Appendix G: Point Shoreline Restoration: Preliminary Feasibility Assessment

Prepared by: Jim Brennan, Marine Habitat Specialist, Washington Sea Grant
University of Washington, October 2007

Review of Conceptual Design

Draft design by Lauren Perry, Bainbridge Metro Park and Recreation District

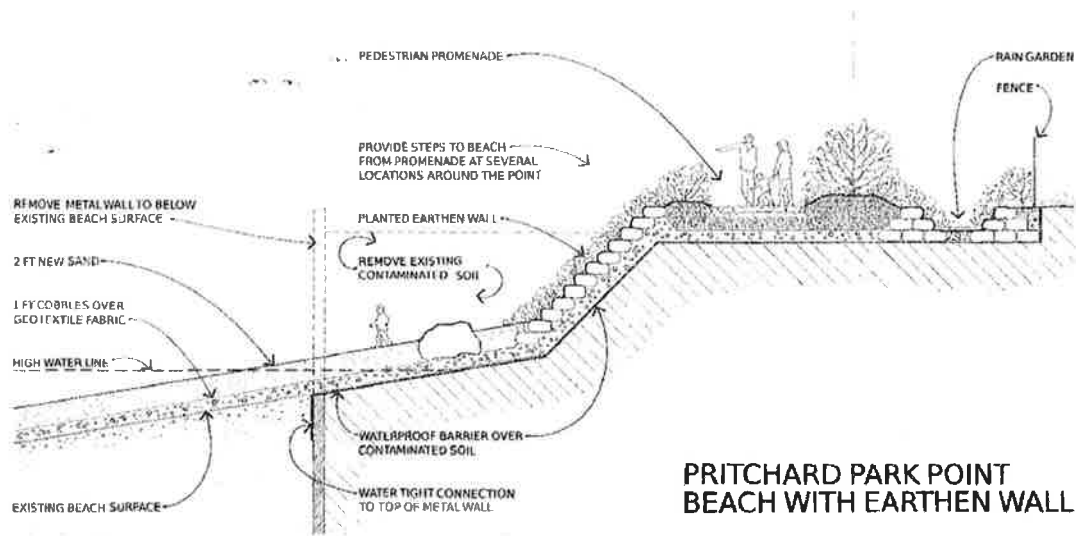
Regarding the conceptual design that was submitted for review, it is difficult to say “will work” or “won’t work” to various parts of the design because there is no scale provided. Tidal elevation is also a critical element needed for considering tidal inundation (at normal and extraordinary tidal/storm events). Beach and bank materials are also critical. The conceptual design specifies 2 feet of new sand. I would not recommend a uniform beach material, but rather a mix of sand and gravel, with size determined by the slope of the beach and wave energy that will act on those sediments. Biological considerations are also important. For example, if one of the goals is to provide spawning habitat for surf smelt and sand lance (beach spawning forage fishes), the beach material specified should be in the range of grain sizes suitable for forage fish spawning. I would not recommend the specified geotextile fabric as underlayment on the beach. This material would likely serve no purpose and would interfere with the natural colonization and survival of benthic infauna (e.g., clams, worms, etc). It is also possible that it may reduce the stability of the sediments and/or become mobile and end up as litter on the beach. The “waterproof barrier” over the contaminated sediments will be a critical element for the success of the project for containing contaminants. I do not know enough about potential impermeable materials that are available, but think that something similar to the materials that are used for liners at toxic waste sites might be suitable, if it can be sealed to the wall.

The location, height, and slope of the bank will also be very important considerations in future designs. The conceptual design suggests that a normal high tide would not touch the bank, but may during a storm. This is a very important consideration. Beach slope and material are important for dissipating wave energy and the bank should be

In addition to the comments above, some consideration may be given to cutting the sheet pile wall slightly higher than depicted in the conceptual drawing; leaving a sill that either matches post-construction beach grade, or is slightly higher than post-construction grade (i.e., after the beach sediments are added). This would help retain some of the beach sediments and might help assure retention of contaminants. It may also serve as an anchor for logs to be installed, but may be located too far waterward. Some thought needs to go into this option because there would also be the risk of having an exposed structure that could be a hazard to beach walkers.

One element of a beach restoration design that is not included in the conceptual drawing is the incorporation of a beach berm. If the elevations are appropriate, the creation of a berm could help reduce the steepness of the bank and serve to protect the bank. It could also serve as a sediment source for the beach in the event of a severe storm. The berm would be composed of large wood, sand/gravel mix, and vegetation. Berms are a natural
